To: T10 Technical Committee
 From: Rob Elliott, HP (elliott@hp.com)
 Date: 24 July 2006
 Subject: 06-263r5 SAS-2 Spread-spectrum clocking

Revision 5 (24 July 2006) Incorporated comments from 20 July 2006 SAS physical WG teleconference - reduced center-spreading range from +2500/-2500 ppm to +2300/-2300 ppm and down-spreading range from +0/-2500 ppm to +0/-2300 ppm so an across-the-board ALIGN insertion rate of 1/128 suffices.

Figure 32 — Transmit data path in a SAS phy

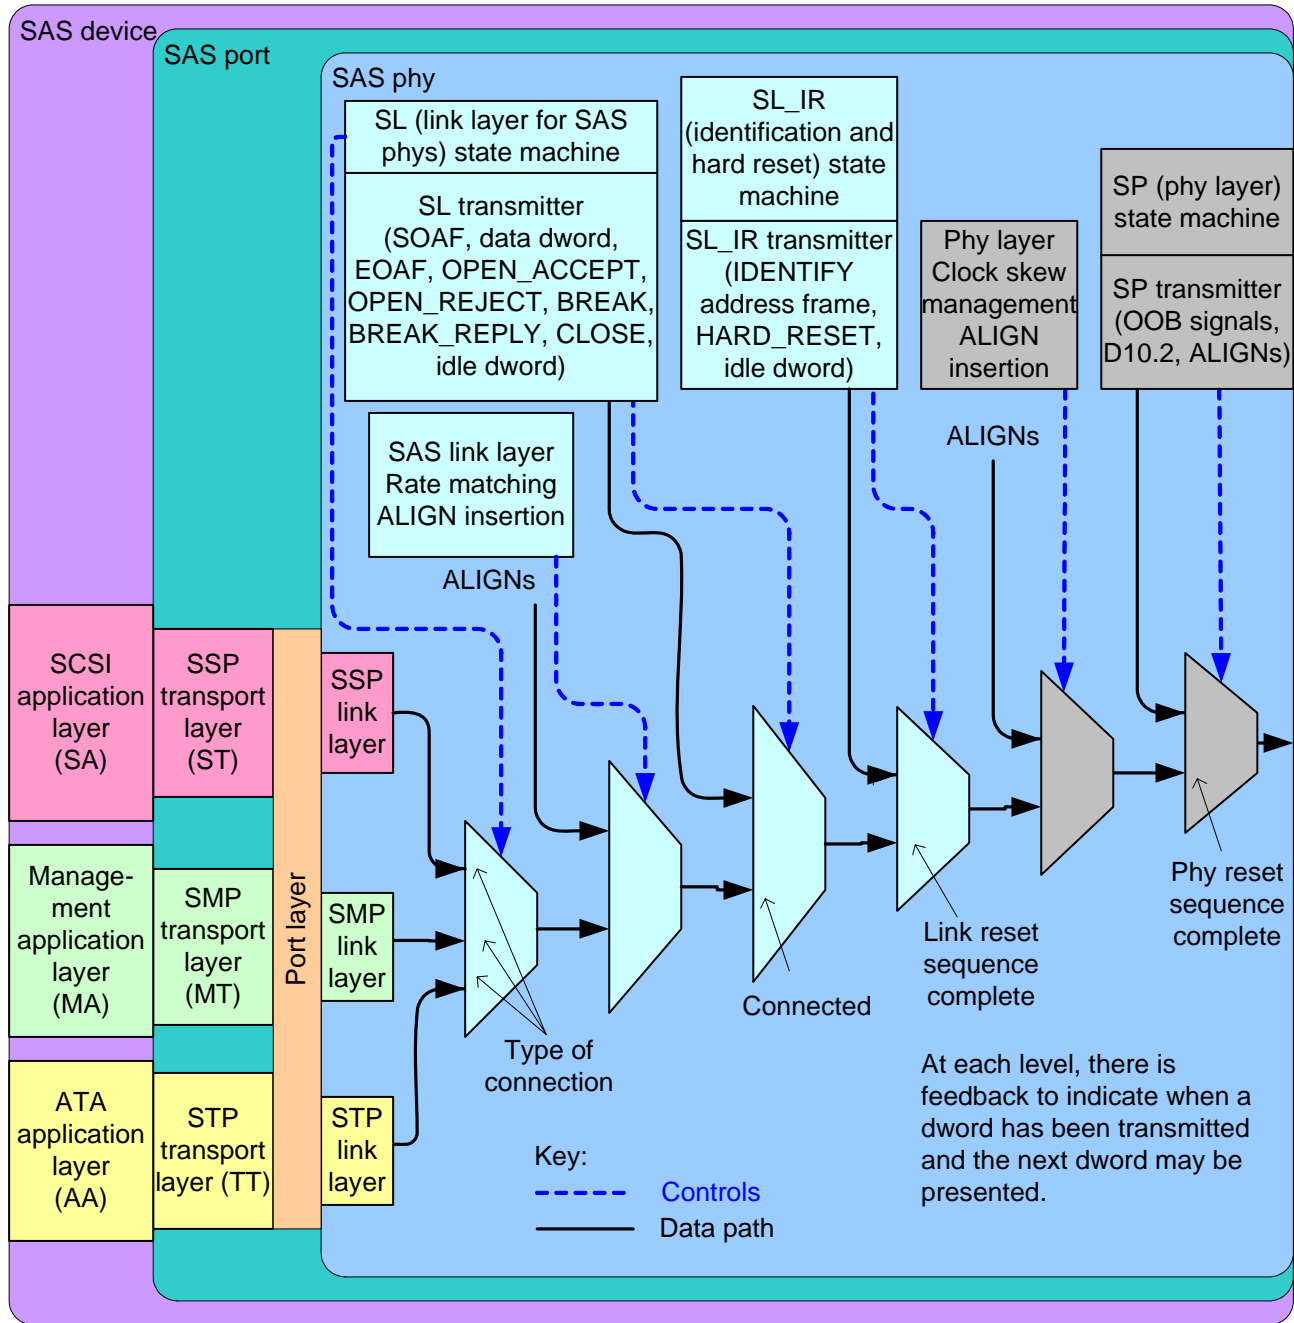
Editor's Note 1: In figure 32, change "Clock skew management" to "Physical link rate tolerance management". Note that 05-381(Multiplexing) also makes changes to this figure.

Figure 33 — STP link, port, STP transport, and ATA application layer state machines

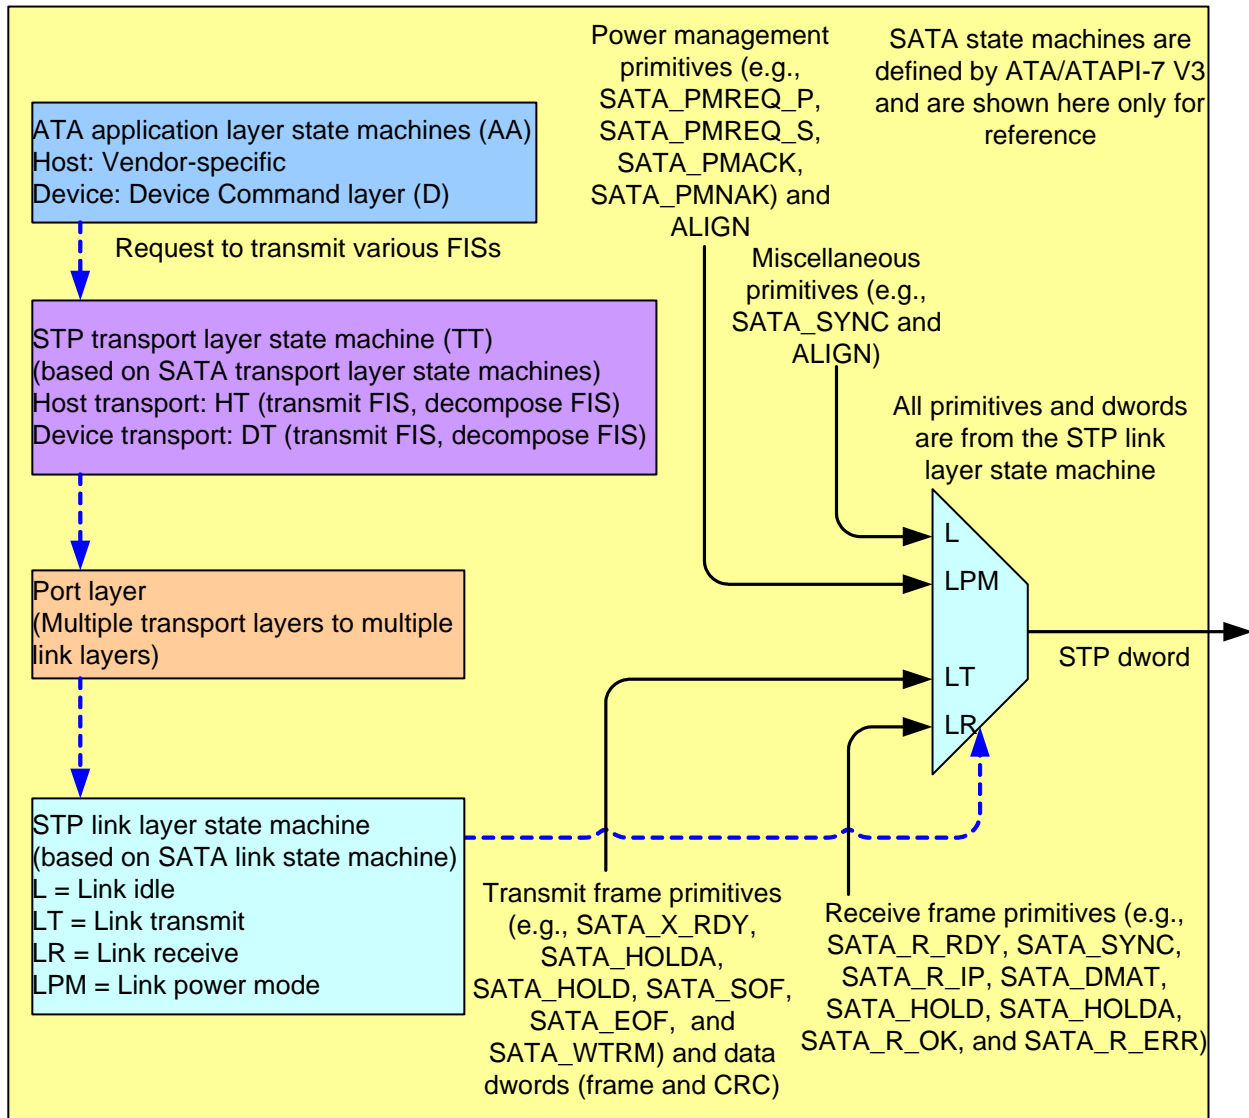
Editor's Note 2: Figure 33 should have included STP initiator phy throttling ALIGN insertion. If the fixed 1/128 ALIGN insertion rate for all types of connections is used instead per this proposal, that is no longer a special case.

Figure 36 — Transmit data path and state machines in an expander phy

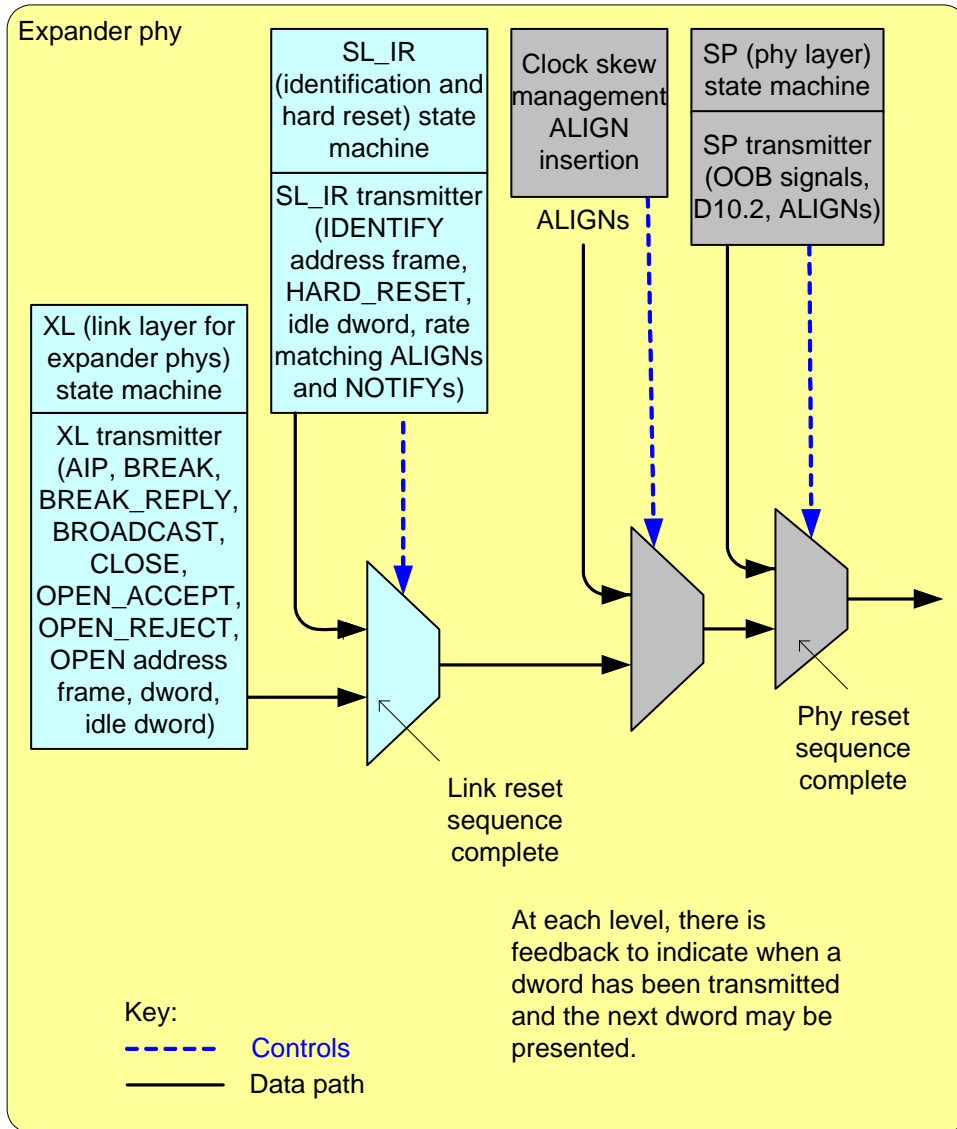
Editor's Note 3: In figure 36, change "Clock skew management" to "Physical link rate tolerance management". Note that 05-381(Multiplexing) also makes changes to this figure.

Figure 37 — Center-spreading tolerance buffer

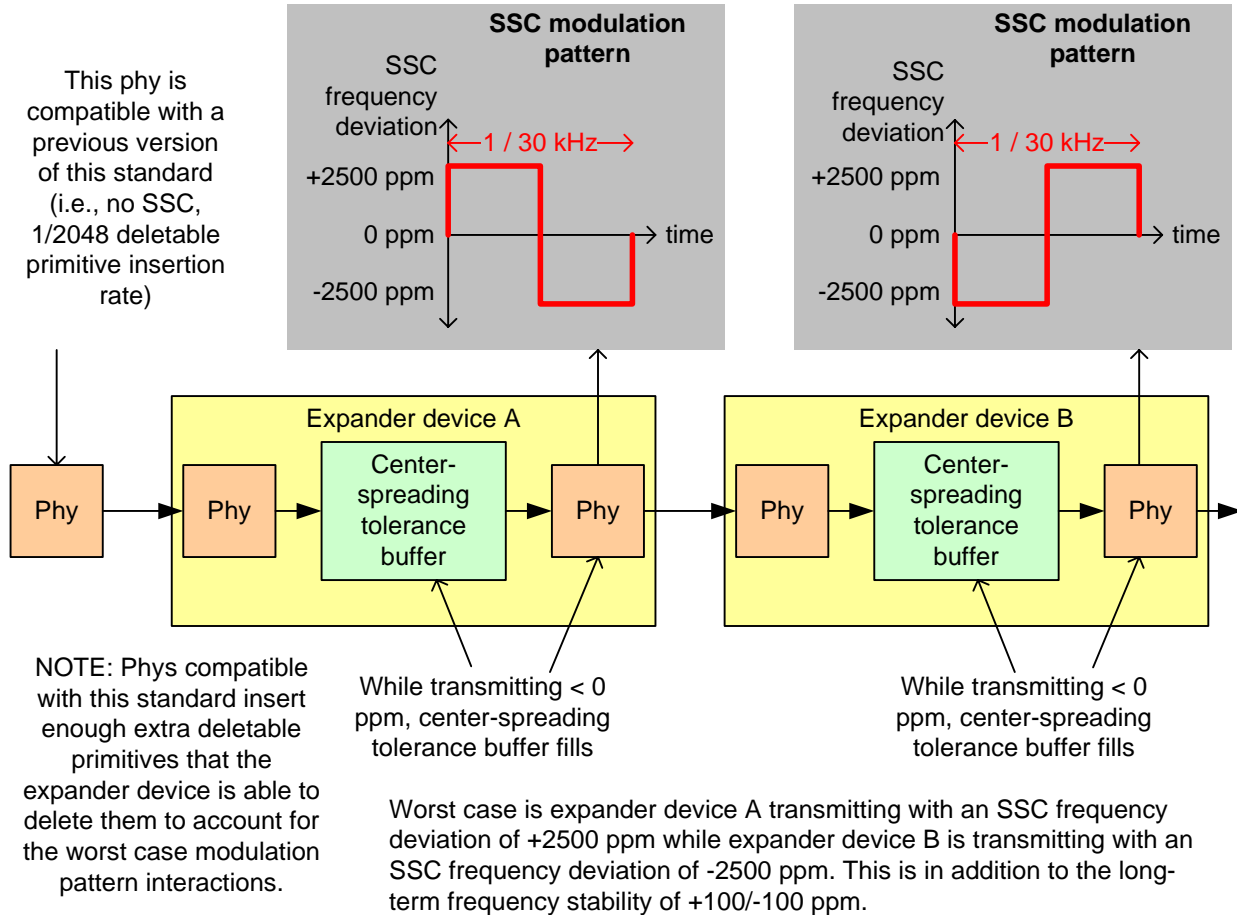
Expander devices forwarding dwords shall support a center-spreading tolerance buffer for each connection with the buffer size defined in table 56 to hold any dwords it receives during the up-spreading portion(s) of the SSC modulation period that it is unable to forward because the ECR and/or the transmitting expander phy is slower than the receiving expander phy and because the dword stream does not include enough deletable primitives. The expander device unloads the center-spreading tolerance buffer during the down-spreading portion(s) of the SSC modulation period when the receiving expander phy is slower than the ECR and the transmitting expander phy.

Figure 37 shows an example of center-spreading tolerance buffer usage.
